**PARKING LOT IMPROVEMENTS 2026  
PIQUA HIGH SCHOOL  
PIQUA CITY SCHOOL DISTRICT**

**ADDENDUM 01**

May 8, 2026

### 4 LICENSE PLATE READER POLE BASE NTS

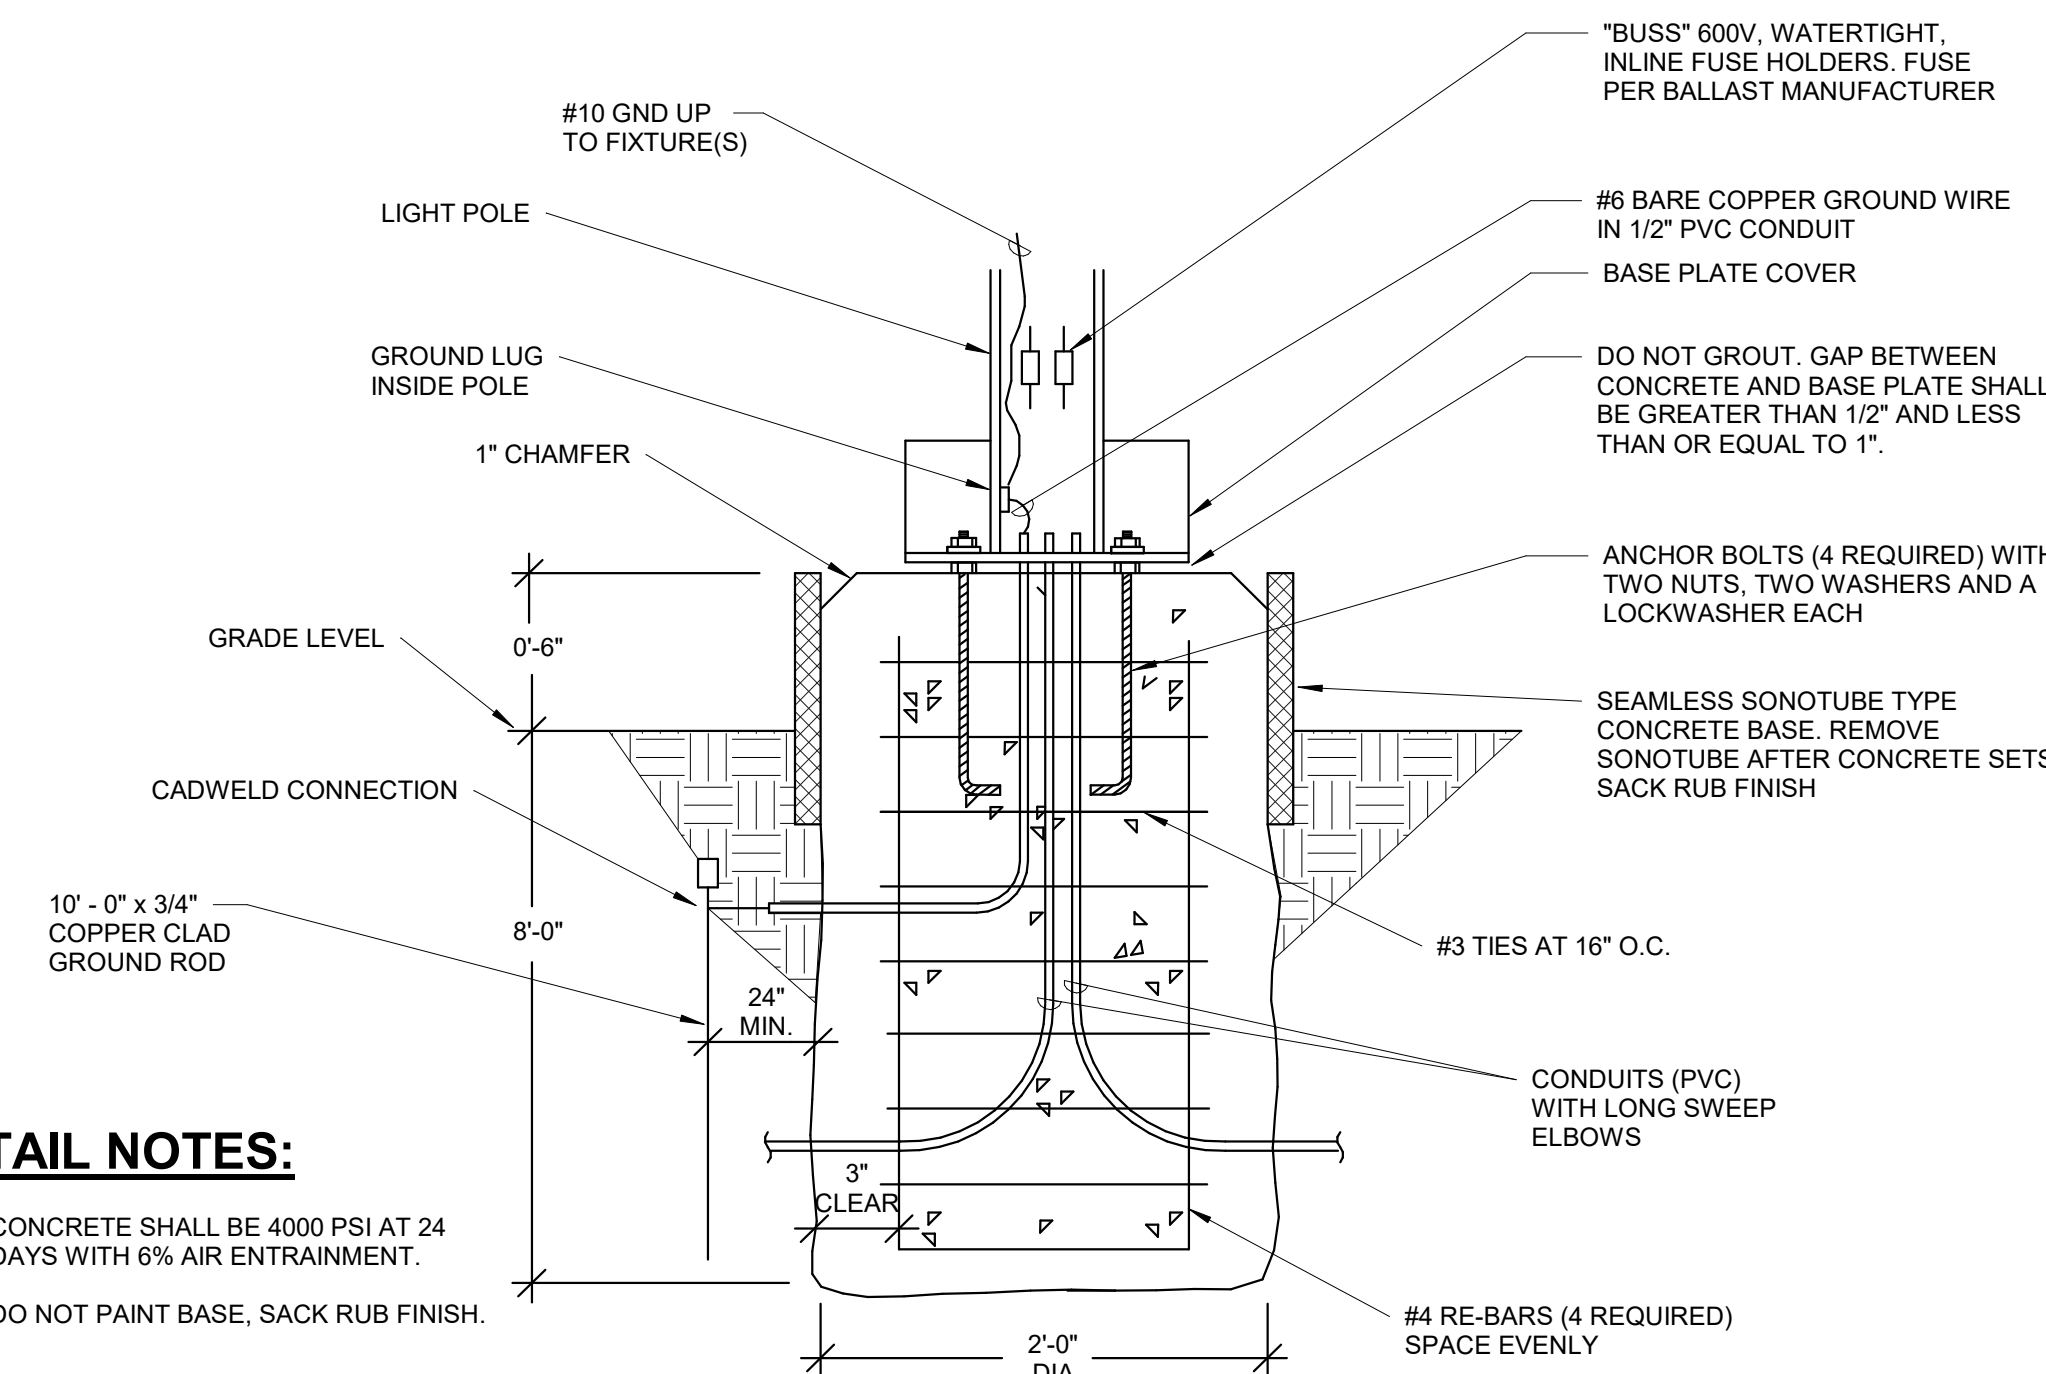
- 2.1. Added License Plate Reader foundation and pole detail.
3. Drawing Sheet E1.1: REPLACE previously issued sheet with the version attached to this addendum.

1 FOOTBALL LOT - SITE LIGHTING PLAN  
1" = 50'-0"

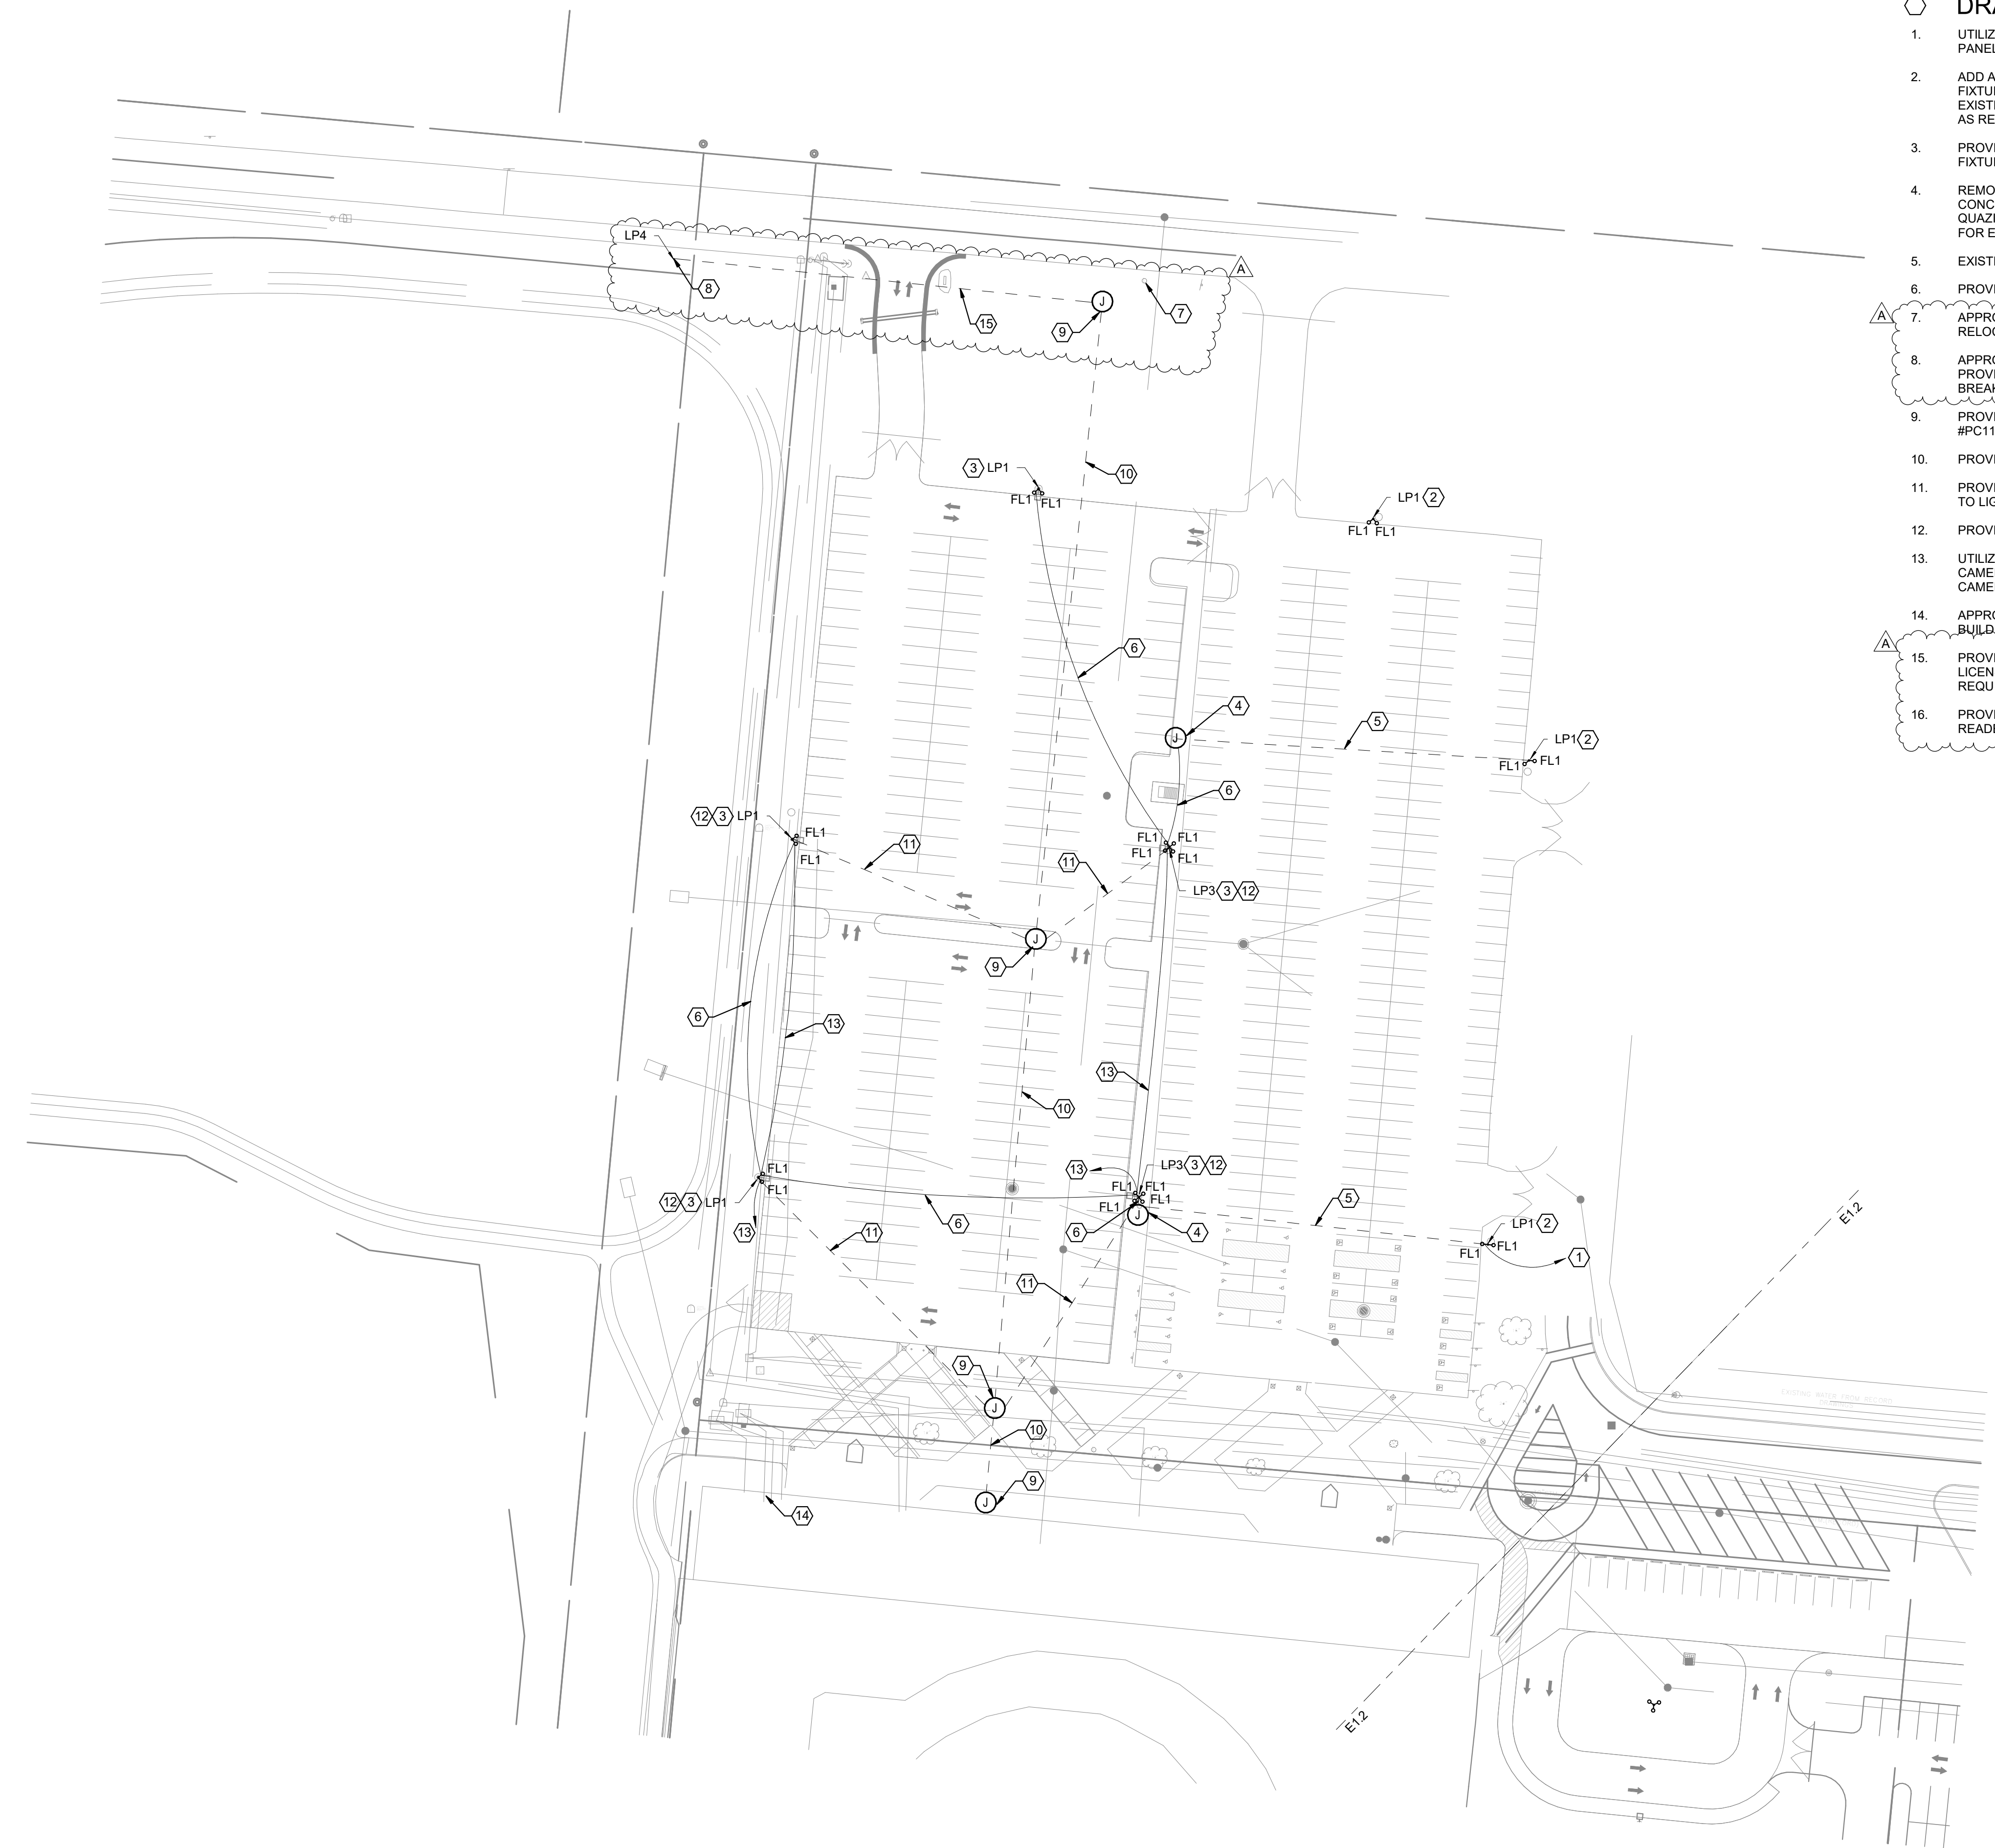
- 3.1. Added License Plate Reader to be relocated with new foundation and pole. Provide data cabling, power and fiber to new location.
4. Drawing Sheet G1.2: The Gate indicated at the east side of the drop off area [Area C] will be installed as part of a future project. Remove keynote 2 from the gate.

- EXISTING LIGHTING CIRCUIT AND CONDUIT.
- PROVIDE (2) #10, #10G IN 1" SCH 40 PVC.
- APPROXIMATE LOCATION OF EXISTING LICENSE PLATE READER TO BE RELOCATED. REMOVE POLE AND CONCRETE BASE 2' BELOW GRADE.

- APPROXIMATE LOCATION OF RELOCATED LICENSE PLATE READER. PROVIDE (2) #8, #8G IN 1" C. FROM STADIUM. UTILIZE SPARE 120V-20A-1P BREAKER IN EXISTING PANEL 'PA-1'.

- APPROXIMATE LOCATION OF PANEL 'PA-1' LOCATED IN FOOTBALL BUILDING.
- PROVIDE 1" CONDUIT WITH PULL STRING TO IN-GRADE PULL BOX FOR LICENSE PLATE READER DATA. COORDINATE NEW DATA CABLING REQUIREMENTS WITH PHS IT DEPARTMENT.

- PROVIDE CONCRETE FOUNDATION AND POLE FOR LICENSE PLATE READER.
